MODIFICATION RECOMMENDATION FORM

*RECOMMENDATION TO CER BY EIRGRID OF MODIFICATION TO GRID
CODE.*

ABSTRACT / TITLE OF MODIFICATION	Fault Ride-Through (FRT) Recommended Modifications
MODIFICATION NUMBER	215
RECOMMENDED AT GCRP MEETING NUMBER	28
LIST OF GRID CODE SECTION(S) AFFECTED BY PROPOSED MODIFICATION:	CC.7.3 and Glossary
CURRENT GRID CODE VERSION :	3.5

Fault Ride-Through Envelopes

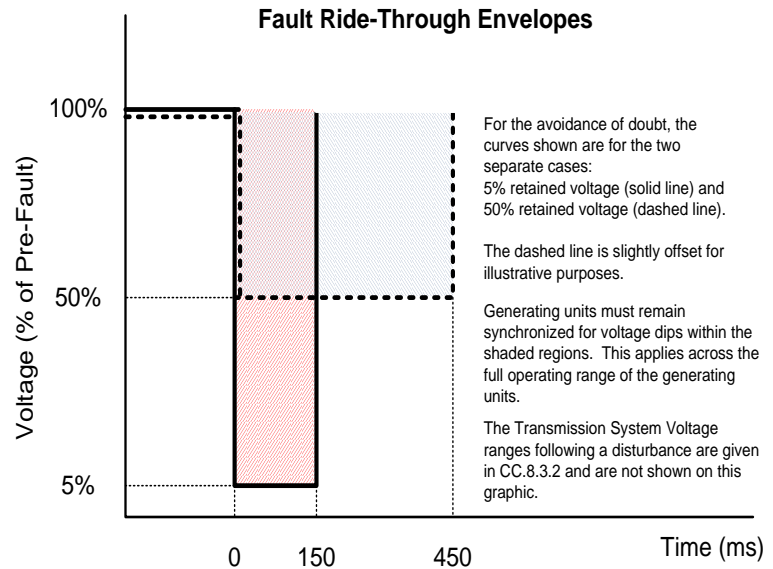
The following is the proposed changes to the Grid Code as put forward by the FRT Working Group and recommended by the GCRP members. Proposed text is highlighted in blue and deleted text is highlighted in red strike-through. Please note that the Figure entitled Fault Ride-Through Envelopes is also a new addition to clause CC.7.3.1.1 of the Grid Code.

- h) remain synchronised during and following any **Fault Disturbance** anywhere on the **Power System** which could result in **Voltage** dips at the **HV** terminals of the **Generator Transformer** of no greater than 95% of nominal **Voltage** (5% retained) for ~~duration 0.2 seconds~~ fault durations up to and including the **Fault Ride-Through Times** as defined in the table below and **Voltage** dips of no greater than 50% of nominal **Voltage** (i.e. 50% retained) for ~~duration of 0.6 seconds~~ fault durations up to and including the **Fault Ride-Through Times** as defined in the table below (see also **Fault Ride-Through Envelopes** below). Following the fault clearance the **Generation Unit** should return to pre-fault conditions subject to its normal **Governor Control System** and **Automatic Voltage Regulator** response~~-. The use of Extraordinary Governor Response and/or Extraordinary AVR Response~~ to remain synchronised during and following a fault is prohibited unless specifically agreed with the **TSO**, such agreement not be unreasonably withheld.

VOLTAGE DIP MAGNITUDE	Fault Ride-Through Times		
	400 kV System	220 kV System	110 kV System
95% (5% retained)	150 ms	150 ms	150 ms
50% (50% retained)	450 ms	450 ms	450 ms
